WARRANTY BULLETIN SAFETY CAMPAIGN

Campaign no.: 2021-0006

Subject: **Move I 1500 Extended Trailer Spindle Weld Failure - Possible Wheel Loss**

sbg2021-005-001

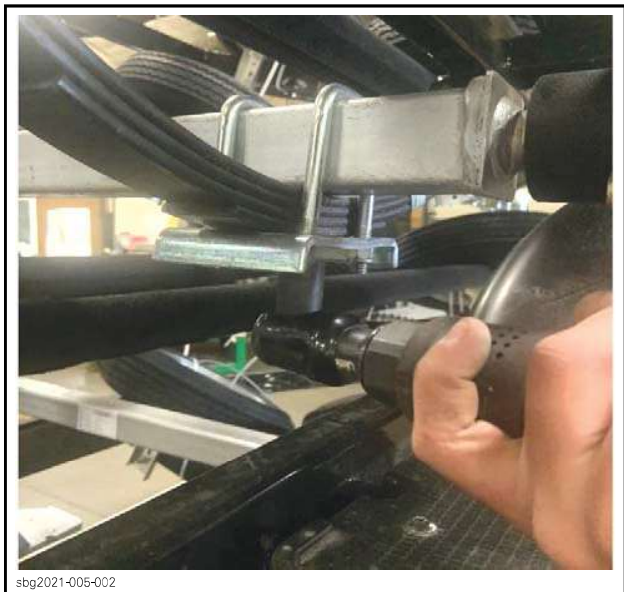
Remove both wheels.

sbg2021-005-002

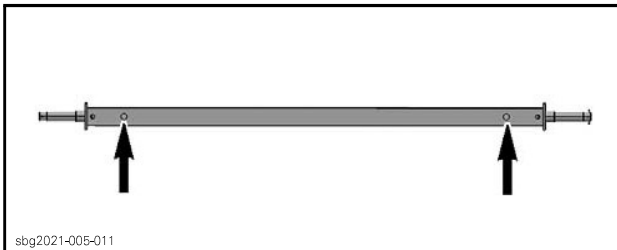
Remove axle assembly by removing and discarding the 4 nuts, the U-bolt and the spring pad on each side.

Remove axle from the trailer.

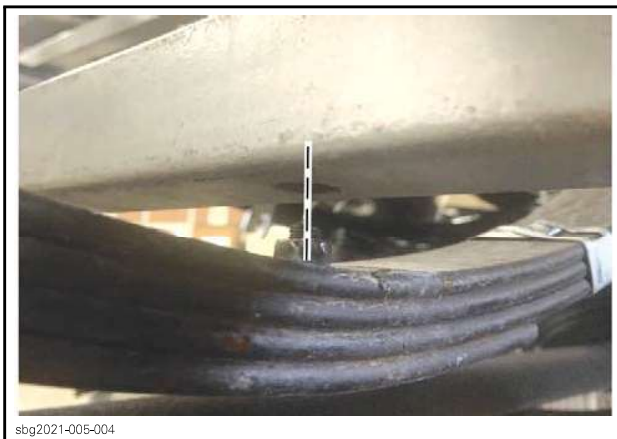
The installation is the reverse of the removal procedure. However, pay attention to the following. Ensure to position the new axle with the locating holes downward.

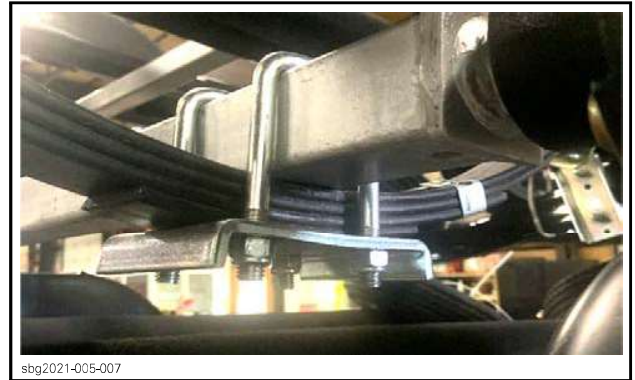
Line up the locating hole in the axle with the centre bolt of the spring stack.

Install the new U-bolts, spring pads and 0.438-14 Centerlock hex. nuts. Tighten to specification.

TIGHTENING TORQUE	
0.438-14 Centerlock hex. nut	34 N•m (25 lbf•ft)
